1. Type of Well ☑ Oit Well 🔲 Gas Well			SEP 1720	1 8. Well Name and No THISTLE UNIT 5	51H 🖌		
2. Name of Operator DEVON ENERGY PROE	OUCTION CO EFMail: trina.couc	-	RECEIVE	9. API Well No. 30-025-41896-	00-X1		
3a. Address 333 WEST SHERIDAN A OKLAHOMA CITY, OK	3b. Phone No. (include area code)		10. Field and Pool, o JOHNSON RA	r Exploratory NCH

CONDITIONS OF APPROVAL Sundry dated 09/9/2014 (FMC Uni-head)

OPERATOR'S NAME:	Devon Energy Production Company, L.P.
LEASE NO.:	NMNM-94186
WELL NAME & NO.:	Thistle Unit 51H30-025-41896
SURFACE HOLE FOOTAGE:	0200' FNL & 0430' FWL
BOTTOM HOLE FOOTAGE	0330' FSL & 0660' FWL
LOCATION:	Section 28, T. 23 S., R 33 E., NMPM
COUNTY:	Lea County, New Mexico

Devon Energy Thistle Unit 51H 13-3/8" X 9-5/8" X 5-1/2"

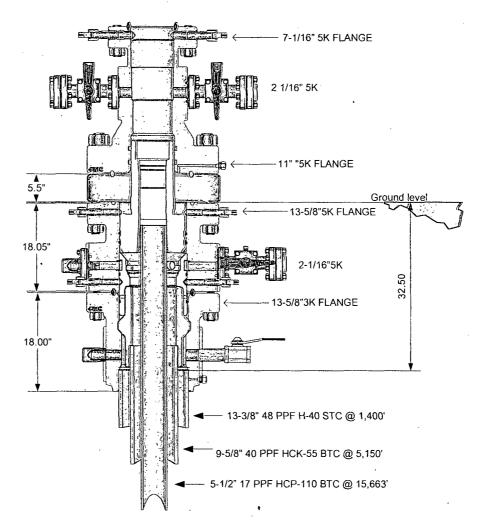
- 1. Operator has proposed a multi-bowl wellhead assembly. This assembly will only be tested when installed on the surface casing. Minimum working pressure of the blowout preventer (BOP) and related equipment (BOPE) required for drilling below the surface casing shoe shall be 3000 (3M) psi.

- a. Wellhead shall be installed by manufacturer's representatives, submit documentation with subsequent sundry.
 - b. If the welding is performed by a third party, the manufacturer's representative shall monitor the temperature to verify that it does not exceed the maximum temperature of the seal.

- c. Manufacturer representative shall install the test plug for the initial BOP test.
 - d. Operator shall perform the intermediate casing integrity test to 70% of the casing burst. This will test the multi-bowl seals.

- e. If the cement does not circulate and one inch operations would have been possible with a standard wellhead, the well head shall be cut off, cementing operations performed and another wellhead installed.
